REF: Z-8004-24

Request - Review and Adoption of Institutional Campus

Master Plan

Location - 2225 Nebraska Avenue

CAMPUS CIRCULATION & PARKING

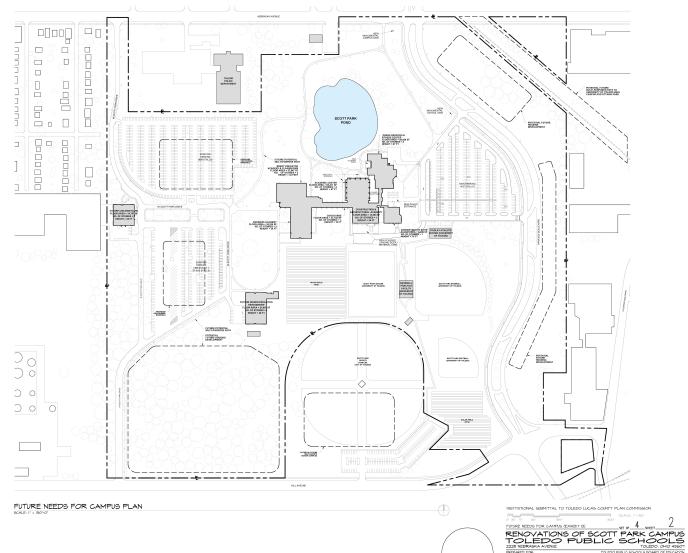
Staff Comment: Based on the proposed number of students there is an excess amount of parking than what would be required, but not enough parent drop-off / pick-up spaces. No bus or parent drop-off / pick-up spaces are proposed for the western parking lots. Additional information needs to be submitted concerning how the overall site is intended to be accessed upon completion of Phase 2 in order to assess the appropriateness of the proposed parking as a condition of approval. Additionally, no bicycle parking is provided on the submitted site plans. Bicycle parking shall be provided as noted by the Division of Traffic Management. A minimum of fifty (50) bicycle parking spaces shall be provided on the site as a condition of approval.

- 26. Per TMC§1111.1304, the Institutional Campus Master Plan must include the average daily traffic and peak hour traffic numbers. This shall be provided to the Toledo Plan Commission staff and kept on file for future development reference.
- 27. Additional transportation and parking management information shall be submitted to assess the appropriateness of the proposed parking. Bicycle parking shall also be provided on the site with a minimum number of fifty (50) spaces per TMC§1107.0901.

Neighborhood Protection Plan & Architectural Design Guidelines (See Exhibit D):

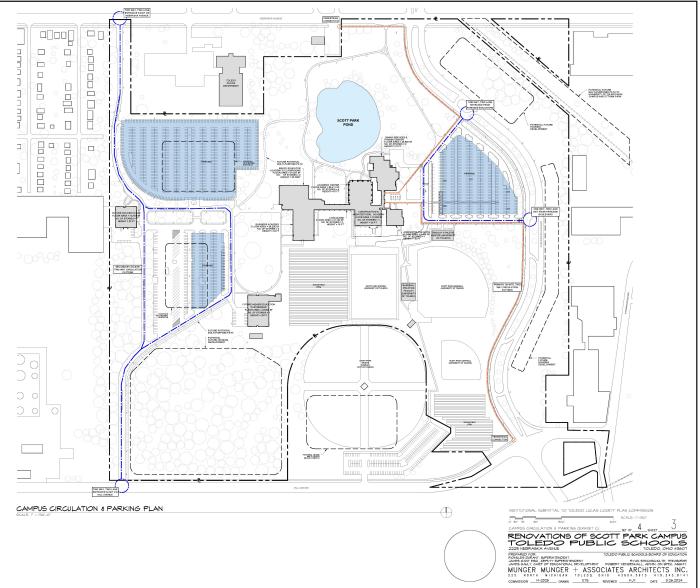
Staff Comment: Established landscape buffers exist on the site; however, there is a lack of appropriate landscape in the buffer along a portion of Scott Park Drive on the northwest part of the site adjacent to existing single-family homes. An appropriate landscape buffer shall be installed as a condition of approval. In addition, a solid evergreen hedge shall be installed along the east parking lot fronting on Parkside Avenue and along west parking along Scott Park Drive to shield the abutting roadway and residences from vehicle headlights as a condition of approval.

- 31. A landscape buffer shall be installed along West Scott Park Drive on the northwest part of the site adjacent to existing single-family homes.
- 32. A solid evergreen hedge shall be installed along the east parking lot fronting on Parkside Avenue and along west parking along West Scott Park Drive to shield the abutting roadway and residences from vehicle headlights.
